REF: 19270 - ROAD WIDTH ASSESSMENT_1.DOCX
YOUR REF:

Re: Road Width Assessment — for Proposed Subdivision of 180 Flowers Road, Binna Burra under DA 10.2022.270.1

Greg Alderson and Associates (GAA) have been engaged to assess the suitability of the roadway construction requirements stipulated in Condition 4 (a) of DA 10.2022.270.1, associated with the proposed subdivision of Lot 3, DP 1259194, into two lots.

Figure 1 - Excerpt of approved subdivision plan with mark-ups in orange

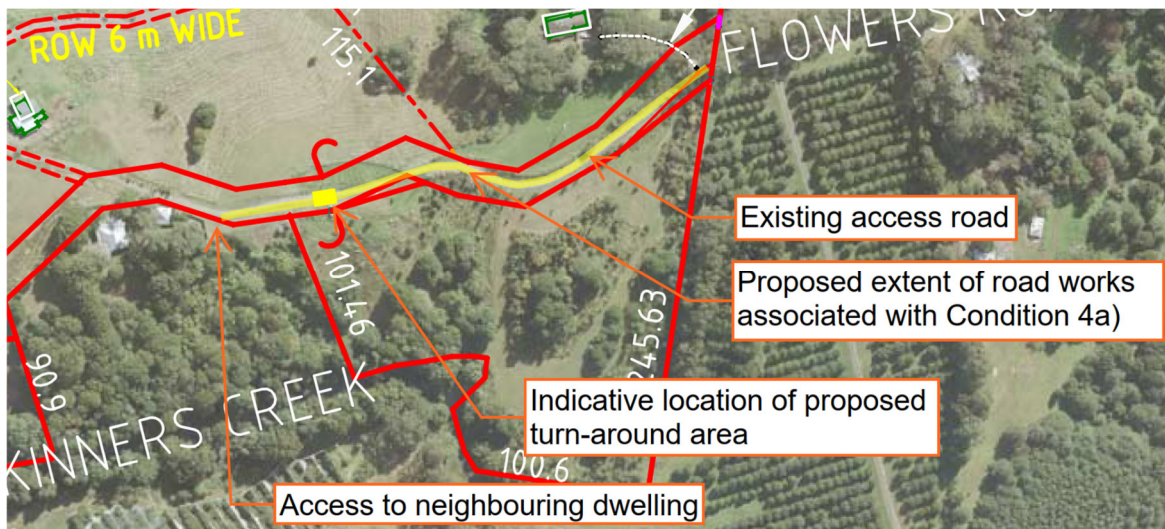
It is understood that it is not the intent of council's condition to upgrade the roadway to the proposed ROW for Lot 2 but rather to the driveway of the neighbouring lot of Lot 10 DP 1084921. An excerpt of the approved subdivision plan is shown below, with the added overlay highlighted in yellow indicating the extent of the existing access road proposed to be upgraded in accordance with the requirements of Condition 4a). This would ensure that the access to neighbouring Lot 10 DP1084921 is not diminished as a result of the proposed development.

Beyond this point the roadway contains some constructability issues with regards to width and will only service the proposed development. By nature, this last section of access road should essentially be constructed / upgraded to the driveway standards outlined in AS2890, NRLG and Planning for Bushfire Protection.
